**From:** [REDACTED] <campaigns@good.do>  
**Sent:** Sunday, 7 August 2016 5:14 PM  
**To:** DPE CSE Information Planning Mailbox  
**Subject:** SIMTA MODIFICATION – SSD 5066 [Early Works]

Submission for Job: #7722 Moorebank Intermodal Terminal Stage 1 Early Works (SSD 5066 MOD 1)

██████████ objects to the Moorebank Precinct West, Intermodal Terminal Facility – Modification, based on the Construction Traffic Impact Assessment.

Figure 4.5 - Measured and estimated spacing as a function of speed for the Eastern Freeway in Melbourne, Australia (including forced flow conditions)

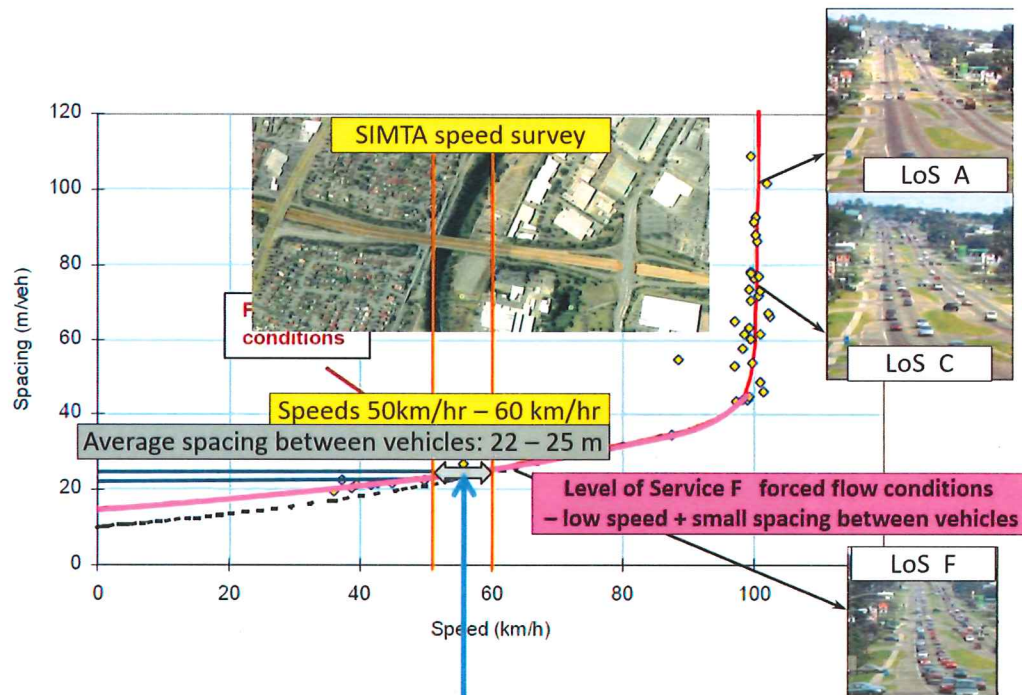
Are there enough gaps (large enough and often enough) for the Intermodal trucks?

The graph shows that the critical spacing is about 45 meters.

For the first EIS, SIMTA conducted a speed survey and found that the speed on the section between the Moorebank Av and Hume Highway was between 50km/hr and 60 km/hr. From this graph, we can see that the spacing between the vehicles would have been, between 22 and 25 meters.

It requires an extremely skilled truck operator to wedge the truck into such a small space – coming down the off-ramp “just in time” and “at the right speed” to fill a gap large enough for the fully loaded truck.

Naturally, the driver, on the M5, suddenly sit behind this truck, and wants to have a “safe” gap. Thus, the driver slows down to make that gap. Obviously, the driver behind it, also wants a safe gap, and slows down too. This chain reaction of ‘wanting a safe gap’ will move, as a wave, upstream.

Effectively, the net impact is that it will reduce the traffic flow speed.

From this graph, we can see that if the speed reduces, the spacing between the vehicles reduces.

The theory states that the traffic flow will reduce.

Since this is common knowledge for traffic and transportation engineers, is omitting the analysis an ethical option?
